**CENTRAL ARKANSAS WATER
JACK H WILSON WATER TREATMENT PLANT
WILSON RENEWAL AND RESILIENCY PROJECT
ADDENDUM NO. 5
JANUARY 30, 2025**

This Addendum forms part of the Contract Documents and modifies the Specifications and Drawings as noted below. Acknowledge receipt of the Addendum in the space provided on the Bid Proposal. Failure to acknowledge receipt of the Addendum may subject the Bidder to disqualification.

DATE:	NOVEMBER 2024
HAZEN NO.:	60711-003
CONTRACT NO.:	1
DRAWING NUMBER:	M1550

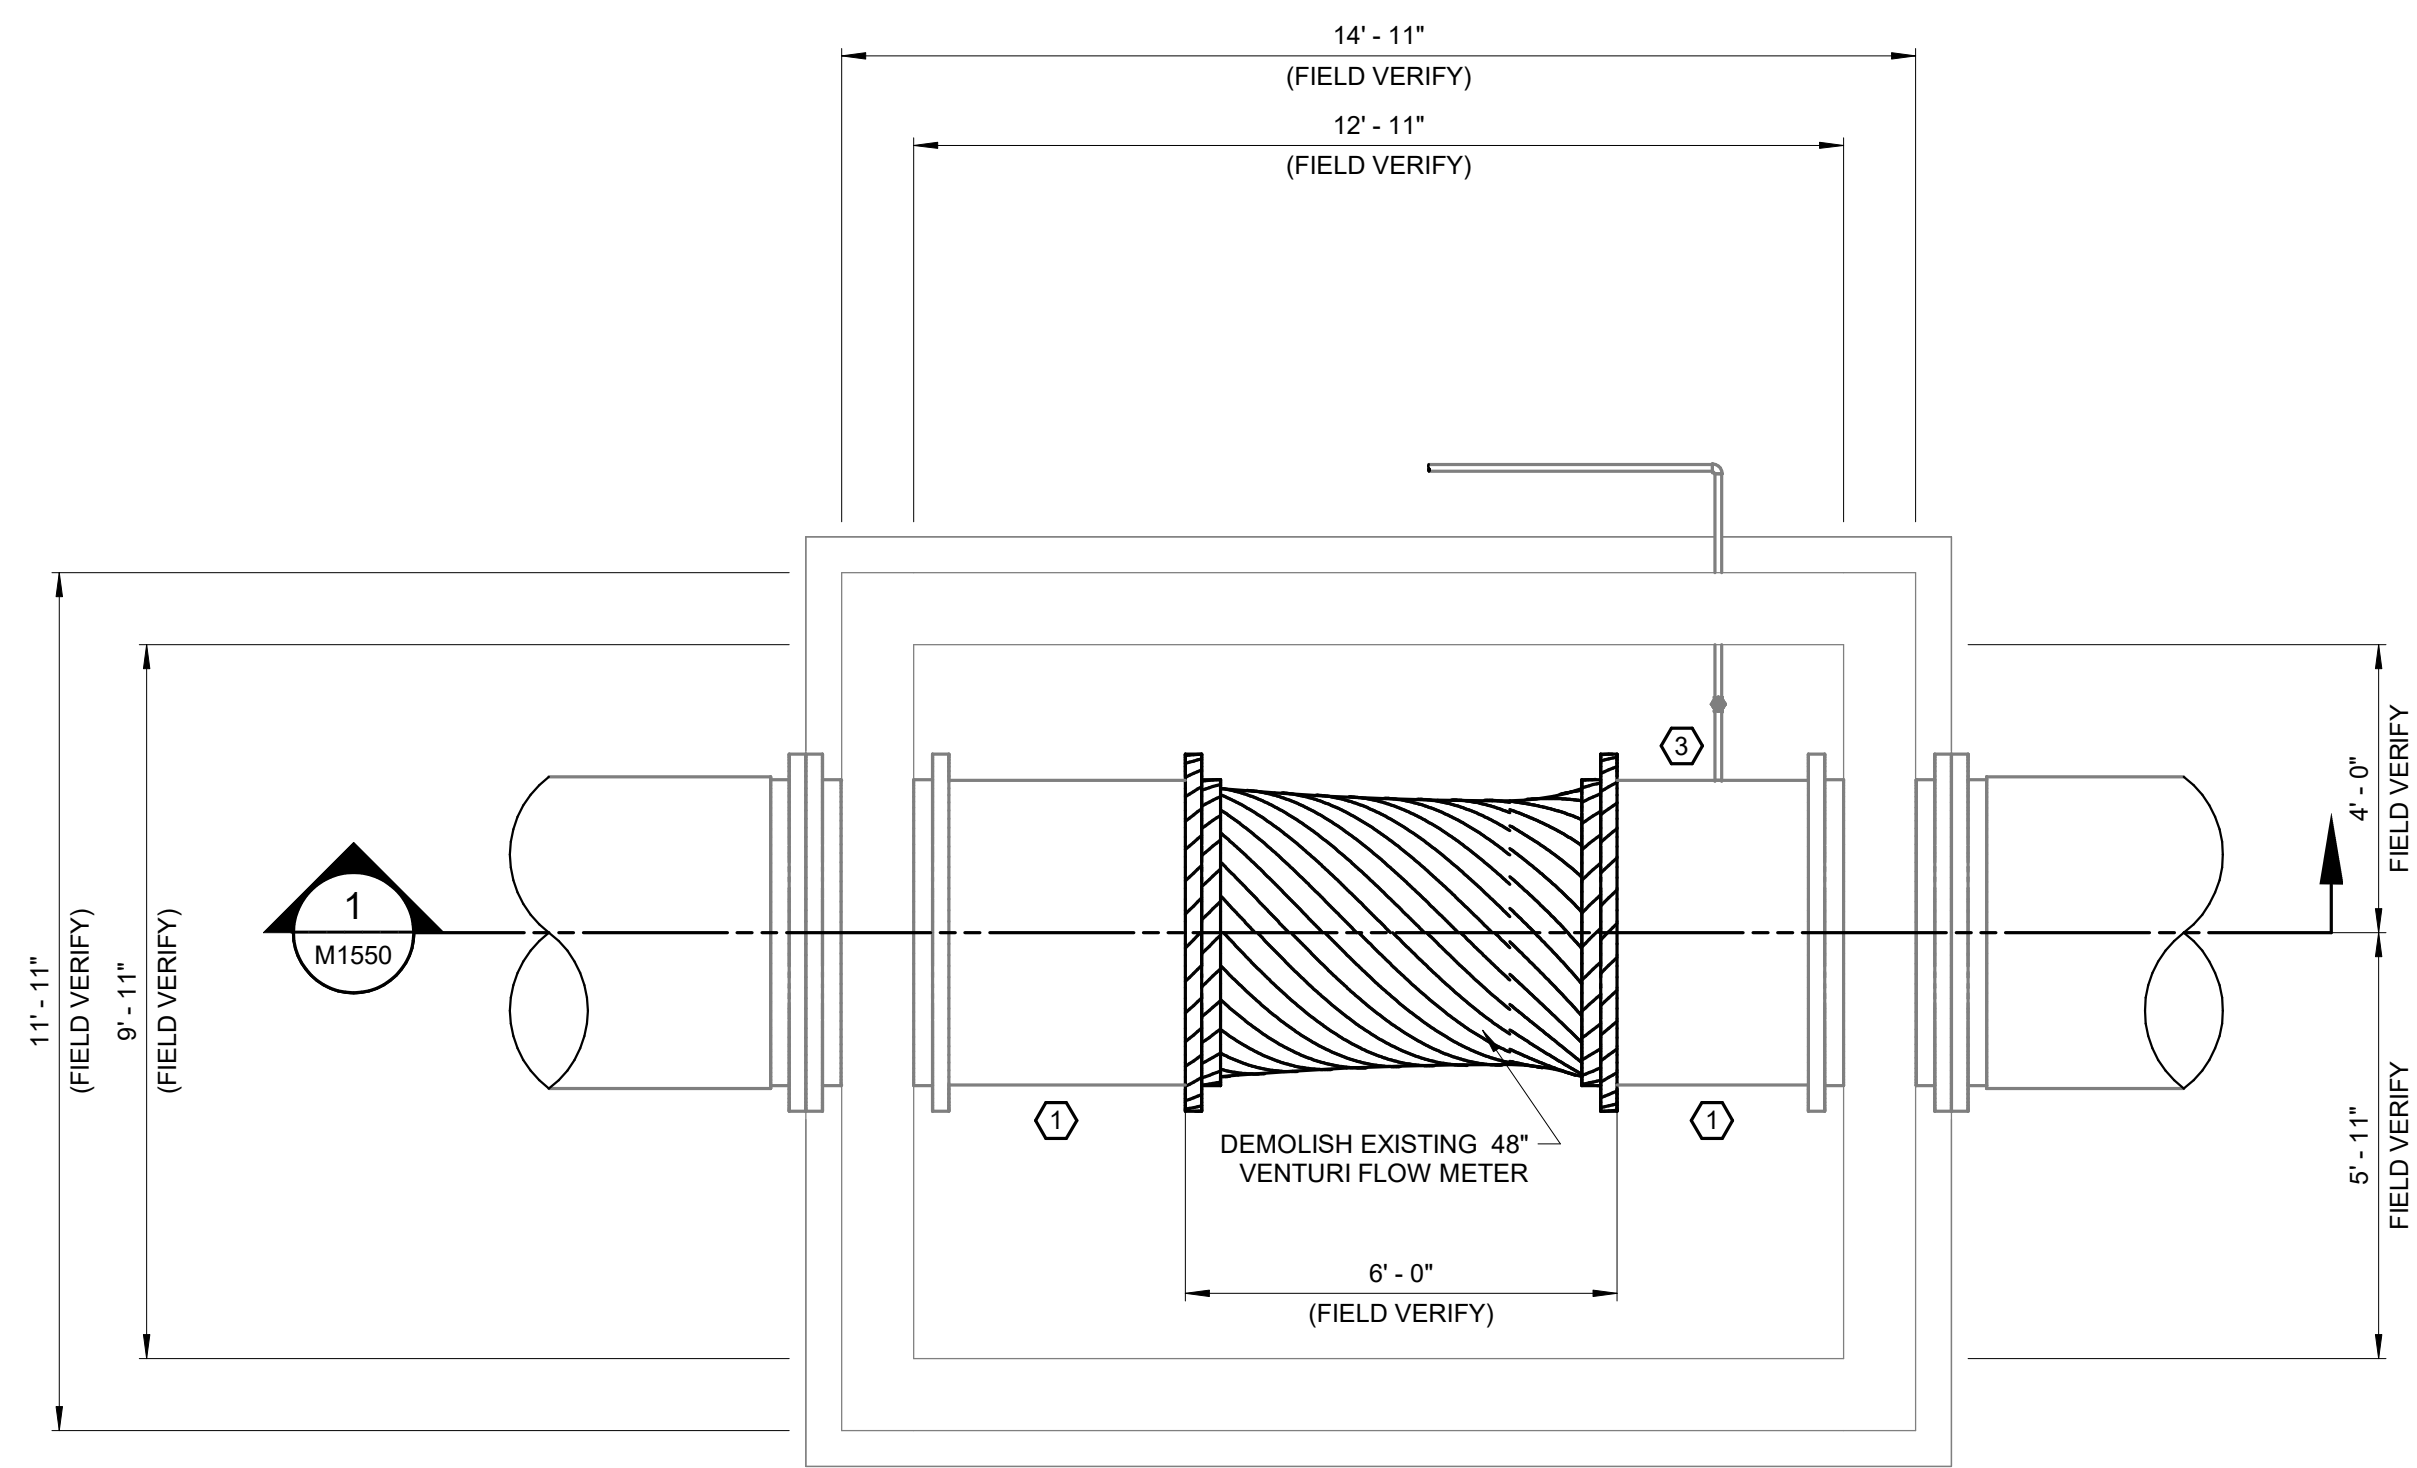
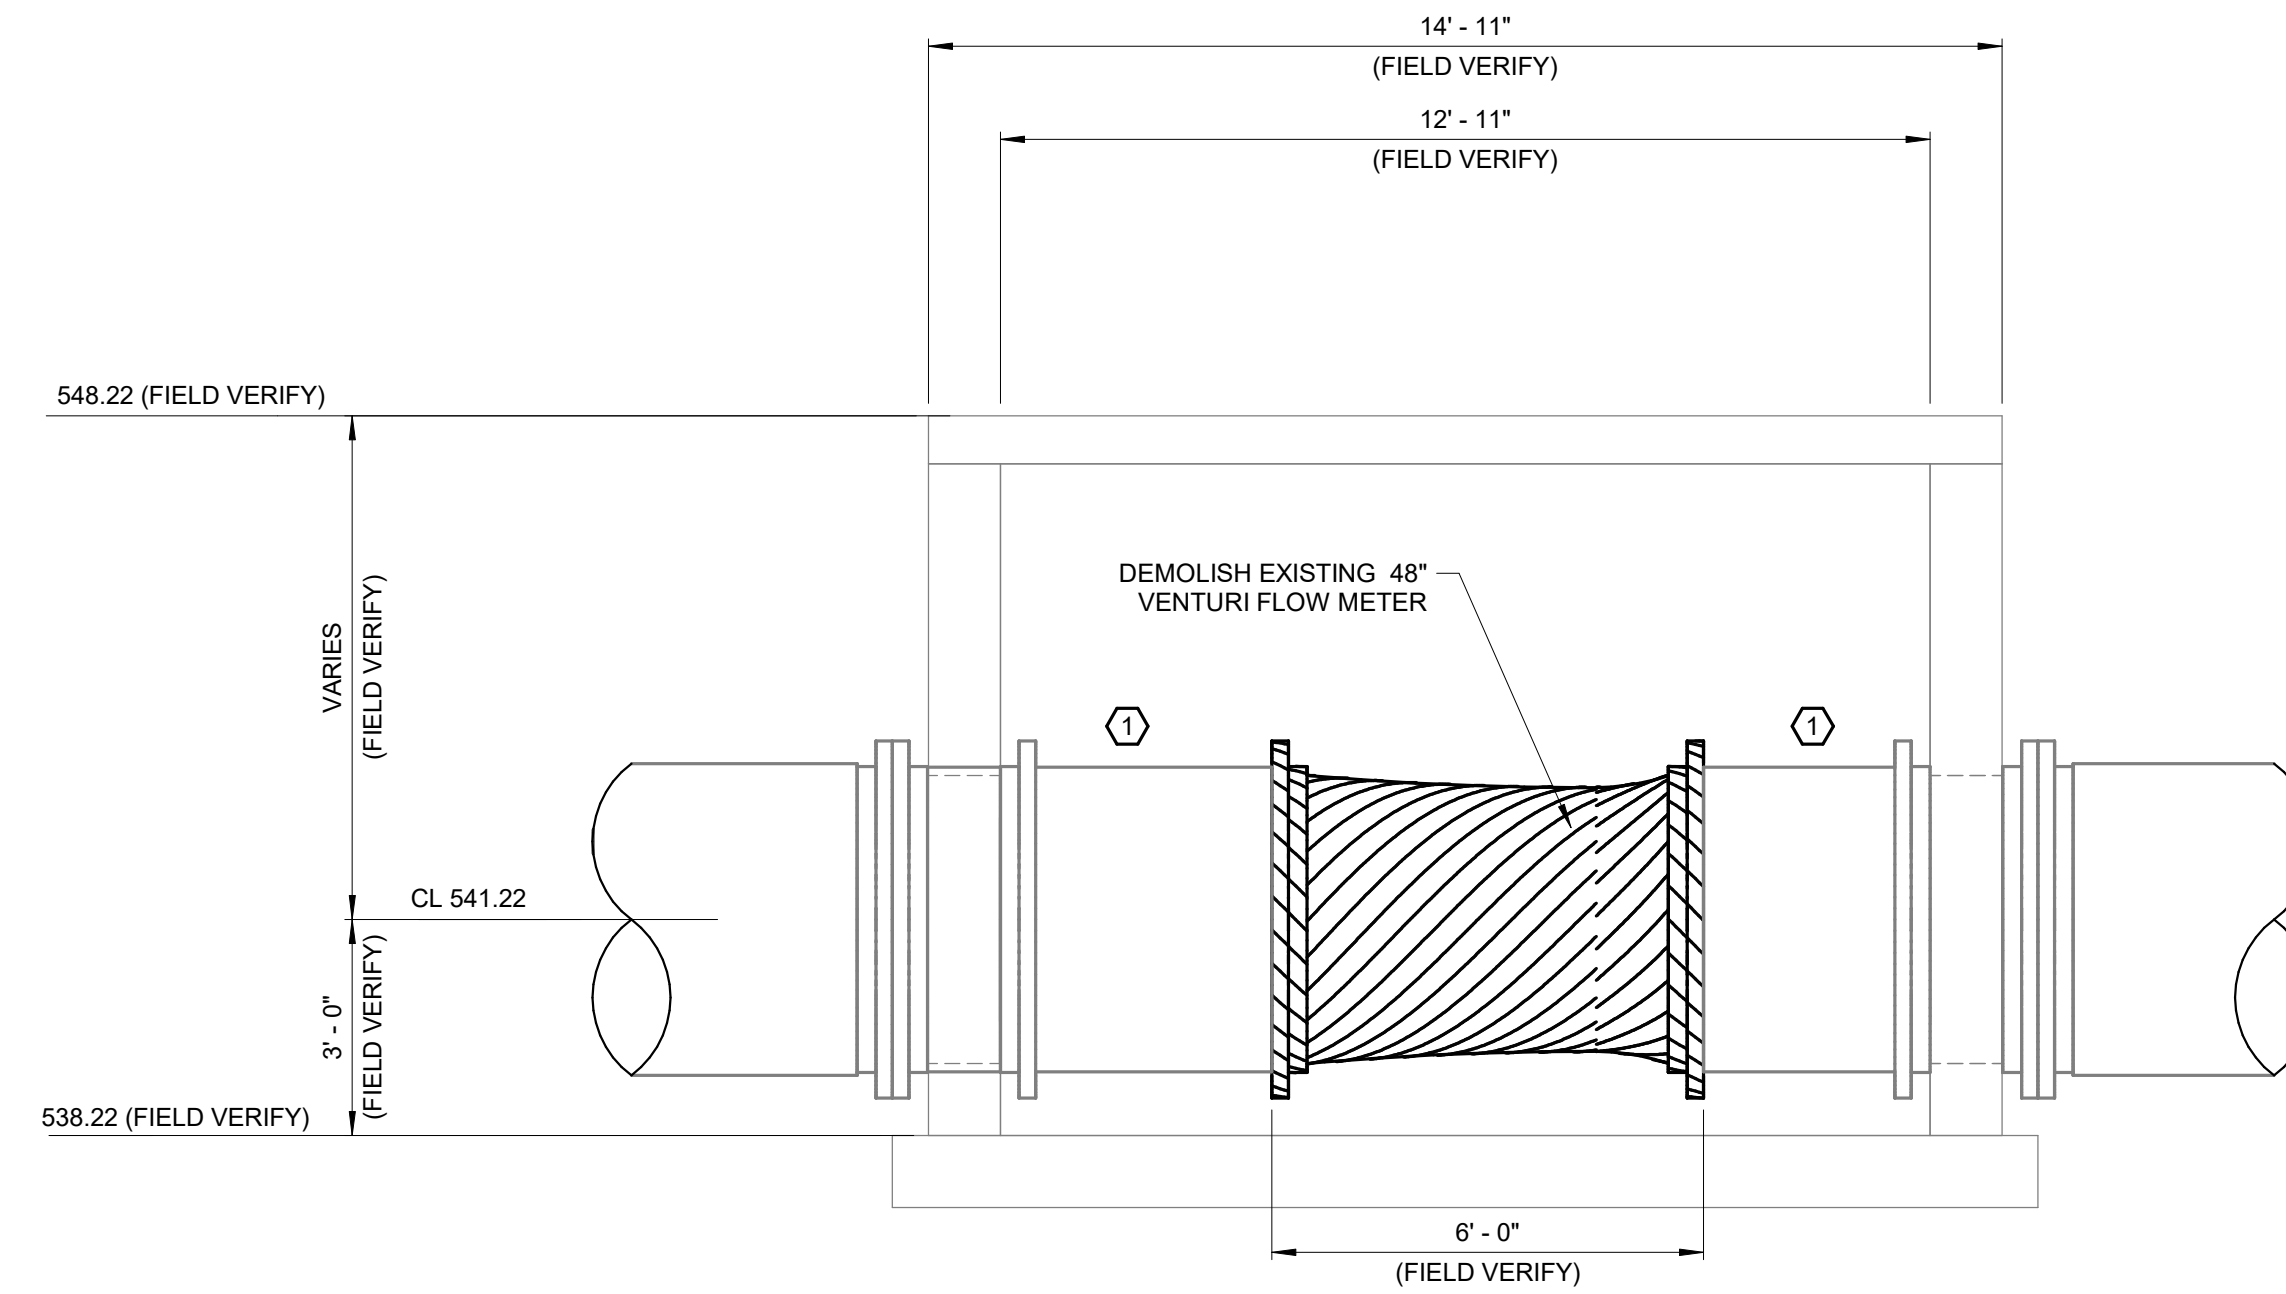
1. Drawing M1550 EXISTING RAW WATER METER VAULT – MECHANICAL – BOTTOM PLAN AND SECTION – DEMO & NEW
 - a. Add the attached new drawing sheet M1550 EXISTING RAW WATER METER VAULT – MECHANICAL – BOTTOM PLAN AND SECTION – DEMO & NEW.
2. Drawing M8001 ADMINISTRATION BUILDING – MECHANICAL – FIRST FLOOR AND CRAWL SPACE PLAN

- ① 48" DIP FL X MJ SPOOL. PERFORM SURFACE PREPERATION AND COATING OF THE EXISTING SPOOL PER SPECIFICATION 09 90 00. PROVIDE NEW MJ AND FLANGE GASKETS PER SPECIFICATION 33 11 13.
- ② REPLACE VENTURI FLOW METER WITH 48" DIP FL X FL SPOOL. LENGTH SHOWN IS APPROXIMATE. FIELD MEASURE TO VERIFY.
- ③ SAMPLE LINE CONNECTION TO REMAIN.
- ④ DEMO EXISTING FLOW METER INSTRUMENTATION. SALVAGE FLOW ELEMENT TO OWNER. TERMINATE ELECTRICAL AT EXISTING JUNCTION BOX.
